Subject: Today's agenda items 6.2, 6.3, and 6.4

re: San Jose to Merced Project Section State's Preferred Alternative

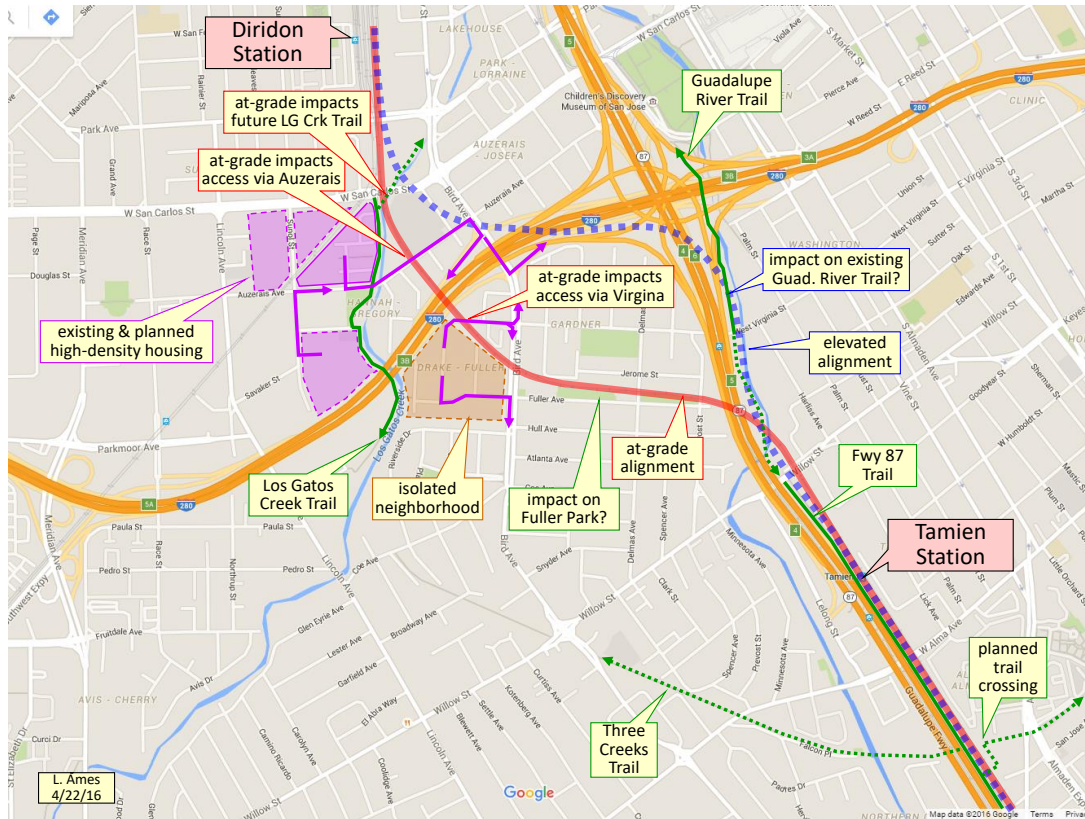
- As I and many others have been saying for years, it is critical for the Greater Gardner and North Willow Glen neighborhoods in San Jose that you select an "elevated" approach from the Tamien Station to the San José/Diridon Station rather than the "at-grade" alignment of Alternative 4. As shown in red in the diagram below, the at-grade alignment would have the daily rush of trains run right through a well-established community, one that is already feeling the impacts of Freeways 280 and 87 and the noise of the recently-expanded nearby airport. The at-grade rail alignment would also impact traffic access to a number of neighborhoods. Adding the needed 3rd set of tracks would probably require taking land from Fuller Park. And the alignment itself, given its close sequence of curves are straight sections, would give passengers an uncomfortably jerky ride. The elevated alternative (shown in dotted blue) stays mainly within the confines of the freeway sound walls: the only private parcels impacted are a few mainly old or empty

commercial lots by Bird Ave. on the north side of the freeway. And being elevated over Bird and within the freeway right-of-way elsewhere avoids traffic impacts to the neighborhoods.

- As shown in my diagram, the HSR alignment will cross a number of existing and planned bike paths, shown in green. Note that these trails allow your customers to reach the station without adding to the area’s traffic congestion: they should be accommodated and encouraged.
